Project: LPS Project D
Bid Package #7636-D

Project No.: 14-022

Addendum No.: 1

CHANGES TO PROJECT MANUAL

FIRST LEVEL - AREA B TELECOMMUNICATIONS PLAN

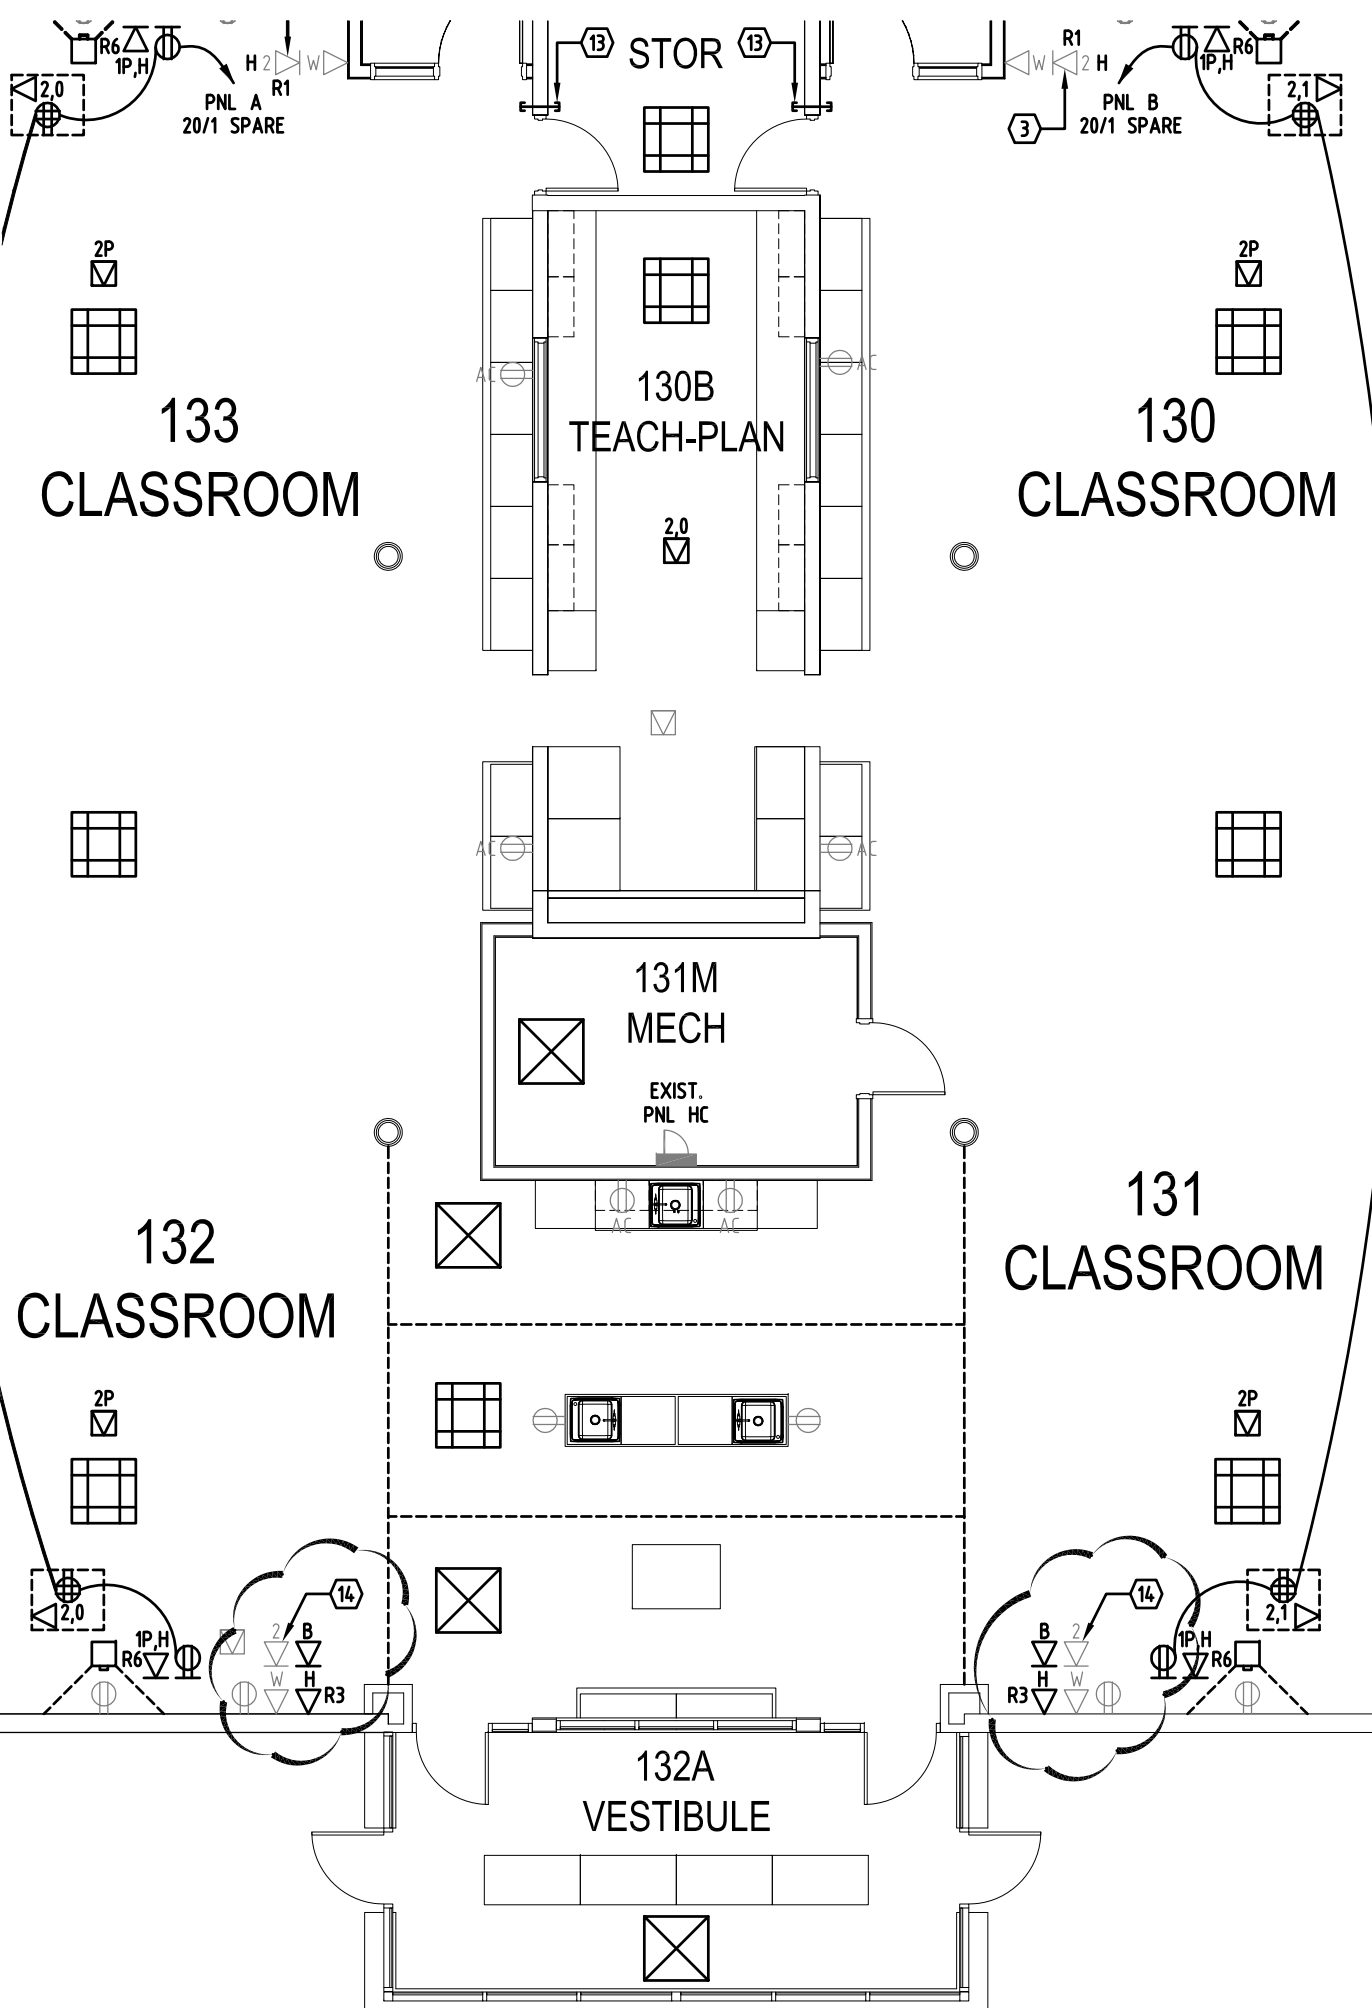
1. Classrooms 121/122/131/132: see attached drawing AD01.140.T01.B-1 with revisions for HDMI projection wall connections. Install new surface mount raceway and boxes for HDMI cabling as indicated. Delete keynote 3 and see new keynotes 14 & 15.
2. Delete (1) quad receptacle at racks in Custodial 181C (TC-A). Install the (3) remaining quad receptacles as detailed in rack elevations on sheet 000.C102.

- KEY NOTES**
- 14. DISCONNECT & REROUTE (2) CAT 6 CABLES TO AV GEARBOX & TERMINATE.
 - 15. TYPICAL. HDMI FACEPLATE CONNECTION TO PROJECTOR & FUTURE AV CONTROL LOCATION.
